Subject:	Improvement of SOT-89B Package
Data Sheet Concerned:	HAL 114, 115, 6251-456-2DS, Dec. 20, 1999 HAL 50x, 51x, 6251-485-1DS, Feb. 16, 1999 HAL 55x, 56x, 6251-425-1DS, April 6, 1999 HAL 621, 629, 6251-504-1DS, Feb. 3, 2000
Supplement:	No. 1/ 6251-531-1DSS
Edition:	July 4, 2000

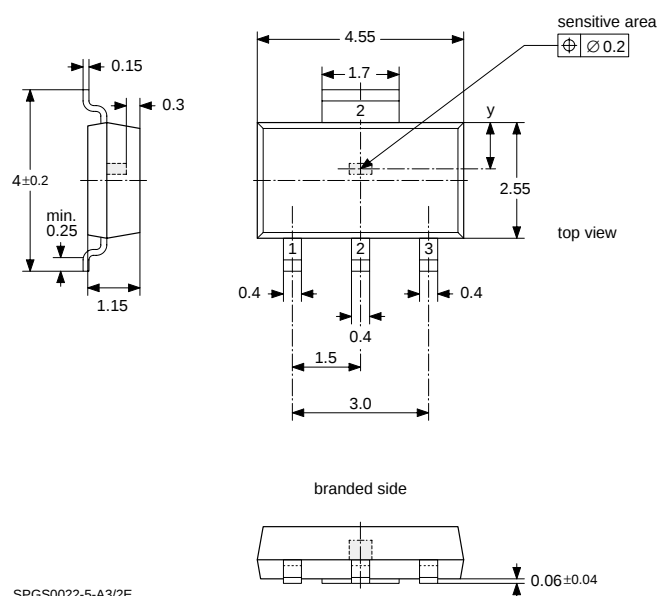
Changes:

- position tolerance of the sensitive area reduced
- tolerances of the outline dimensions reduced
- thickness of the leadframe changed to 0.15 mm (old 0.125 mm)
- SOT-89A will be discontinued in December 2000

Position of sensitive area

HAL 114, 115 HAL 50x, 51x HAL 621, 629	HAL 55x, HAL 56x
x	center of the package	center of the package
y	0.95 mm nominal	0.85 mm nominal
